# City of Richmond

## Report to Development Permit Panel

**File:** DP 18-797785

**Re:** **Application by Sian Group Investments Inc. for a Development Permit at 9680 Williams Road (formerly 9620, 9640, 9660 & 9680 Williams Road)**

## PROPOSED TOWNHOUSE AT 9620-9800 WILLIAMS RD RICHMOND SITE PLAN 1/F

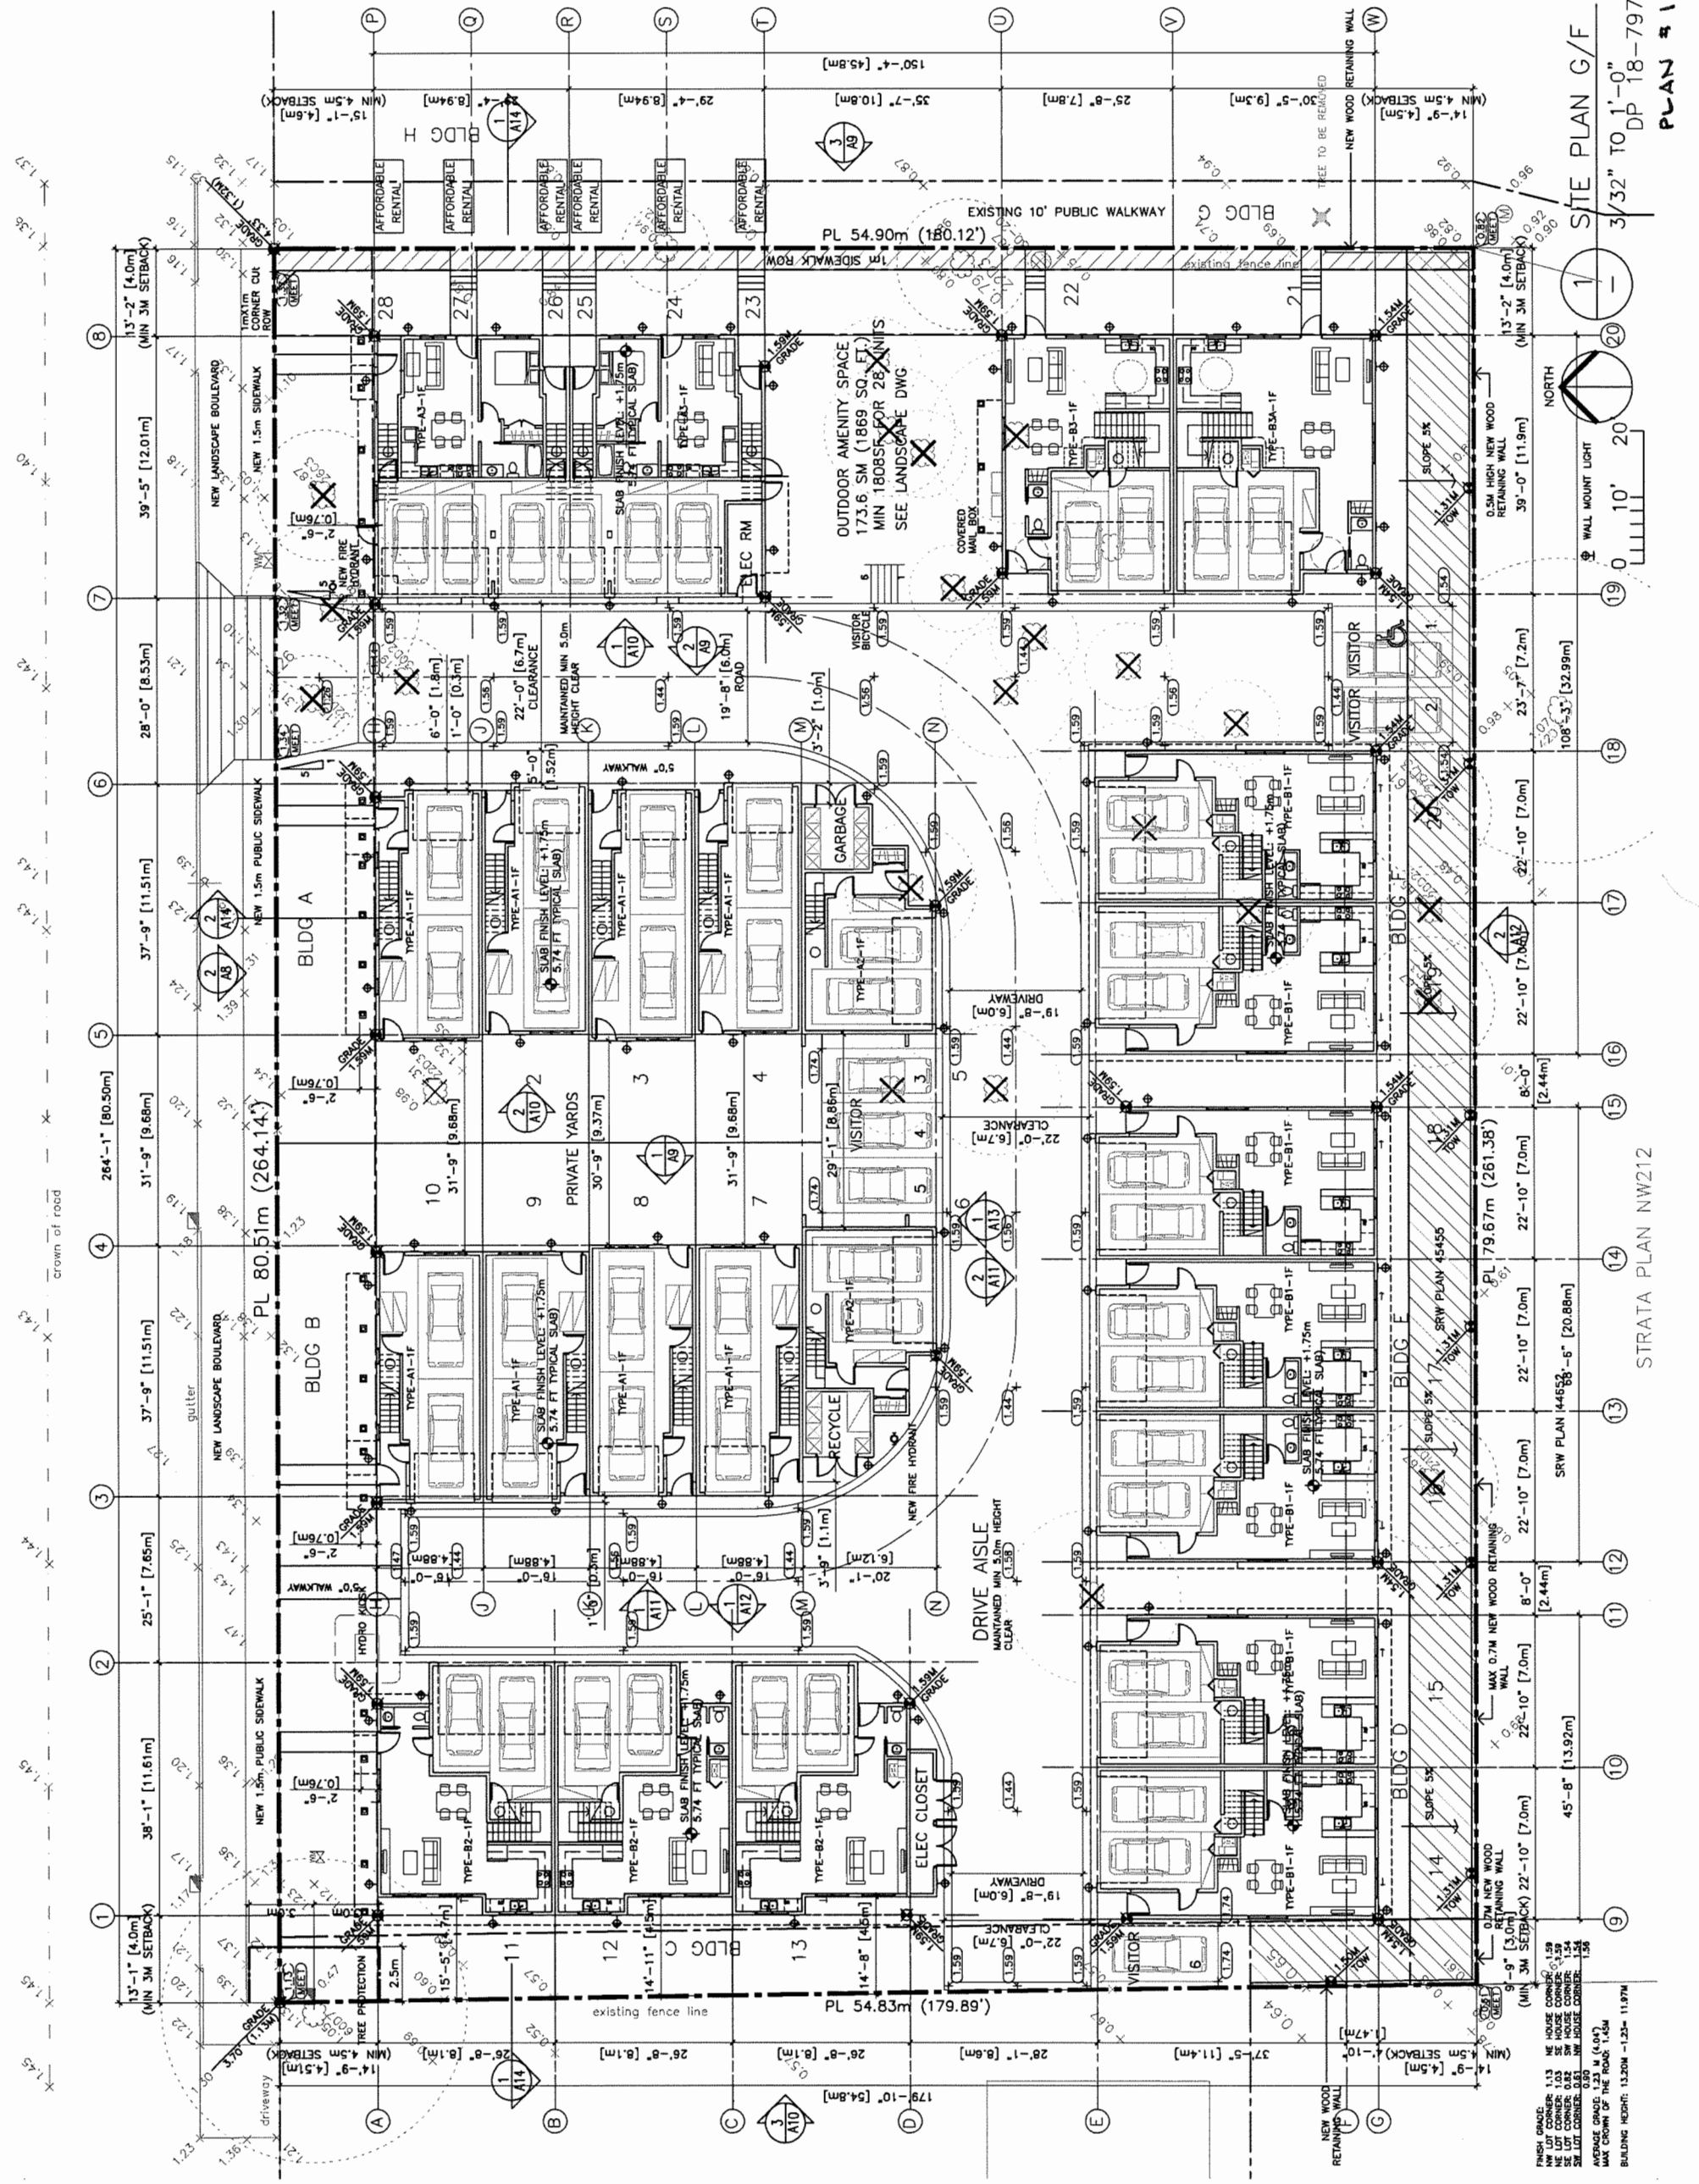
- agree with Panel comment to install an additional pedestrian walkway from Williams Road to the internal drive aisle to enhance pedestrian access to Buildings B and C;  
*Pedestrian walkway has been provided.*

- agree with Panel comment regarding the provision of an additional pedestrian access point between Buildings B and C from the internal drive aisle to Williams Road.

5'-0" x 3'-0" HEIGHT WOOD FENCE 1/2" = 1'-0"

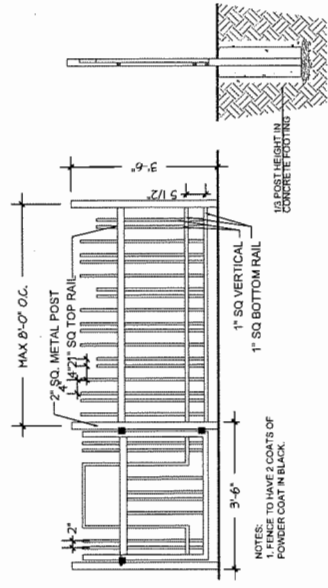
- the five-foot high wood fence is too high as the site is already dense; a three-foot high fence is adequate as it will provide opportunities for social interaction with neighbours;

- agree with Panel comment that the five-foot high fence be lowered to three feet;  
*This comment has been addressed as described above.*
- not concerned with the slope on the outdoor amenity area as it is not too steep;  
*Noted.*

**TREE MANAGEMENT PLAN**

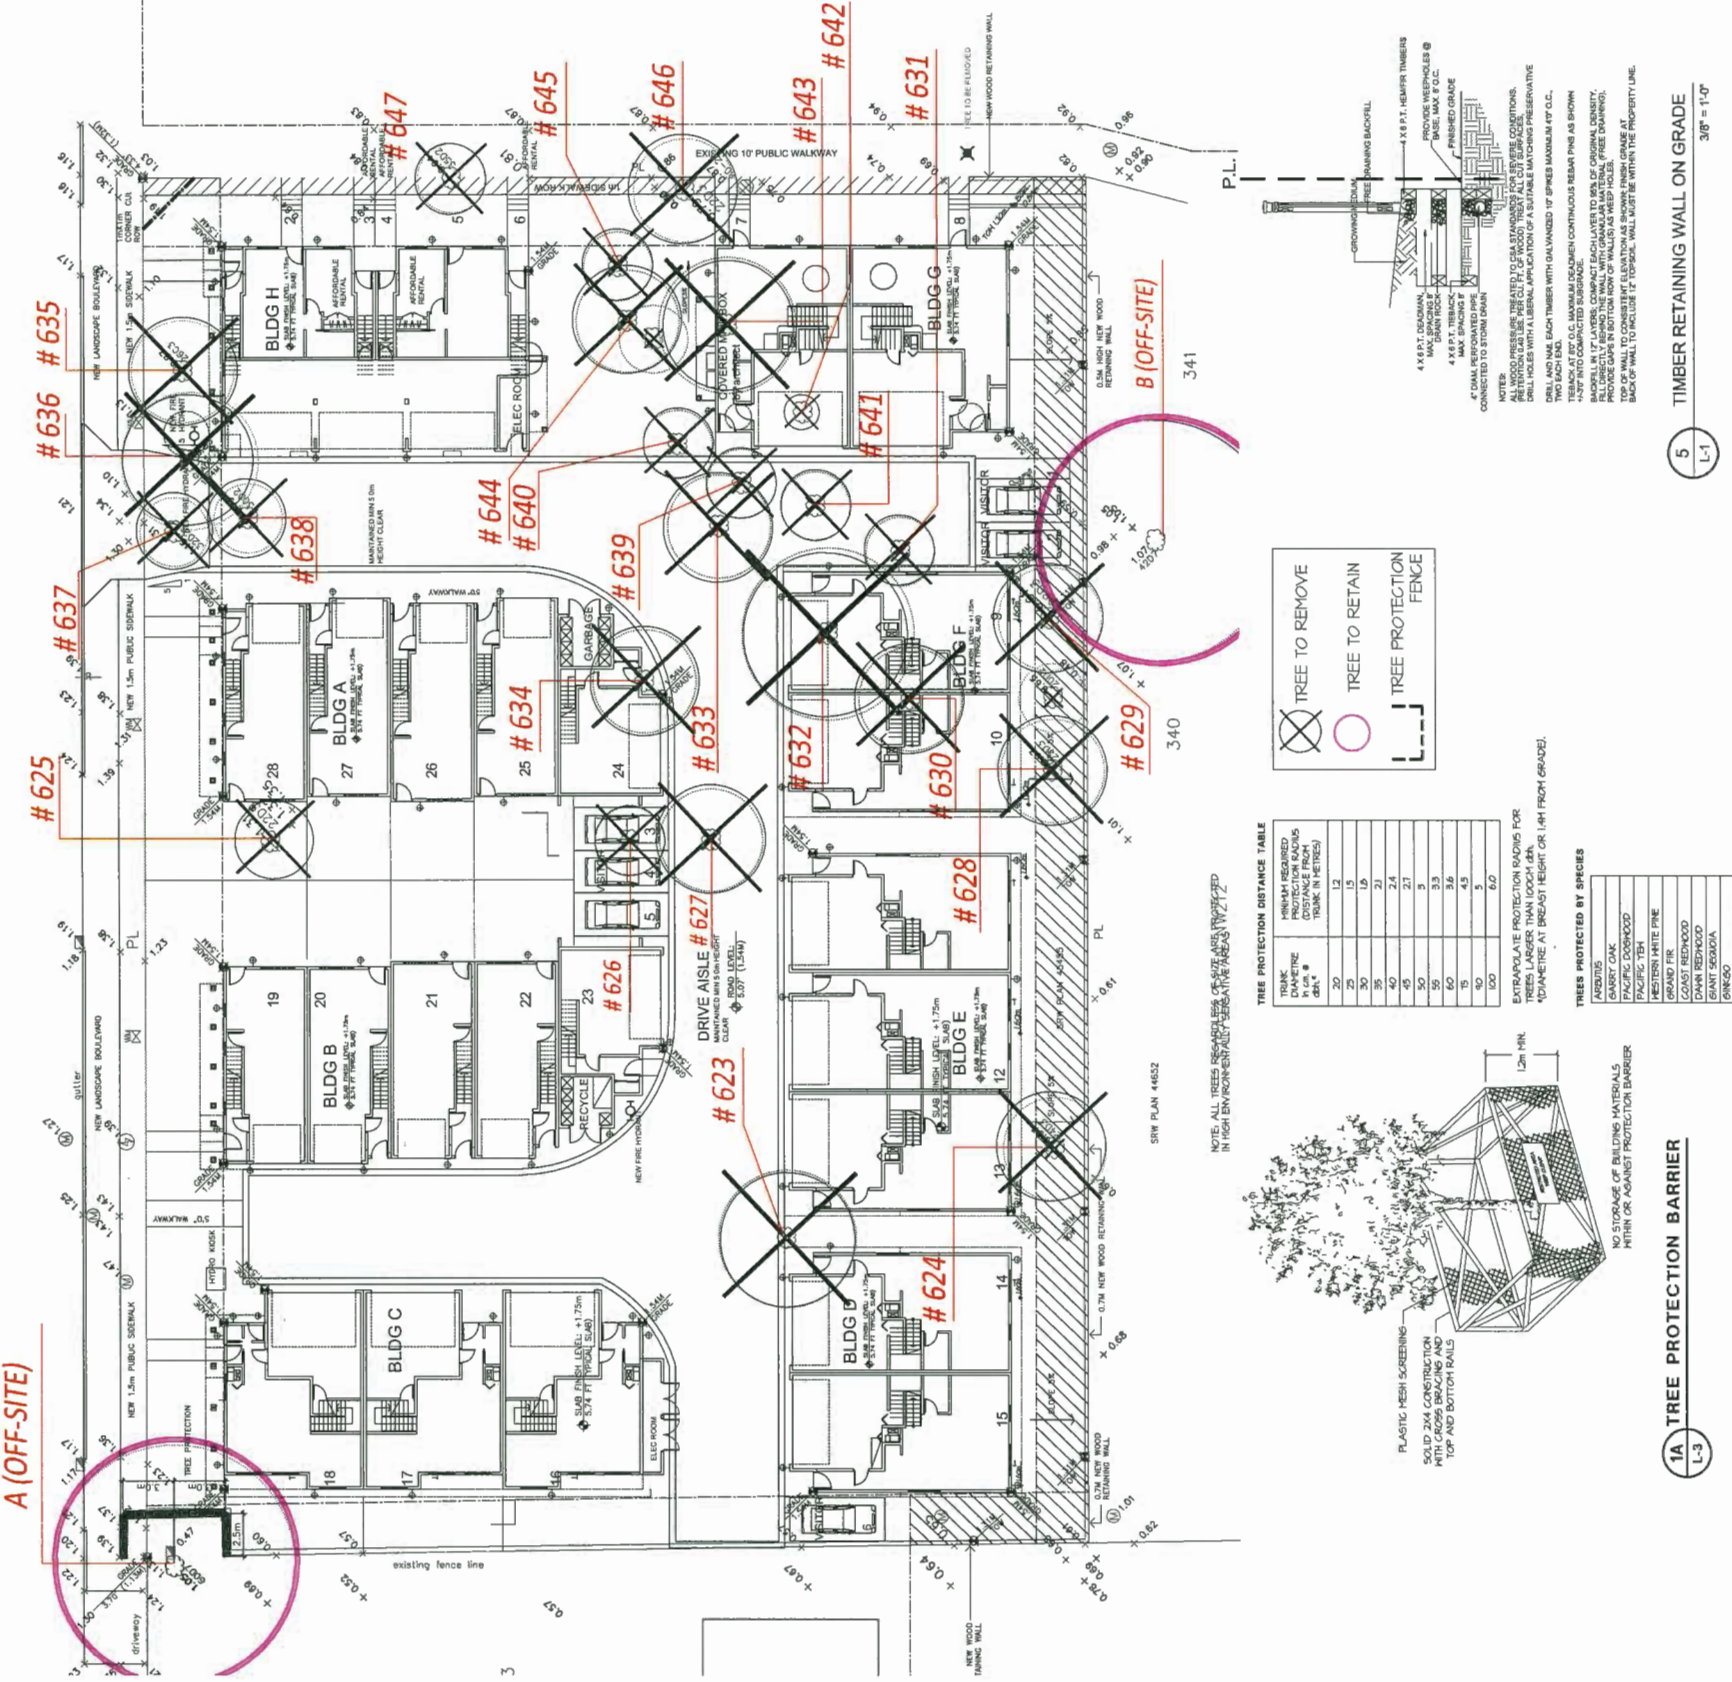
- tree management plan does not provide information on the condition of trees to be removed; better accounting of existing trees is needed; suggest that the cash-in-lieu for trees to be planted in Richmond should ensure that replacement trees be planted close to the site losing the trees;  
*Tree management plan has been revised to address this comment.*
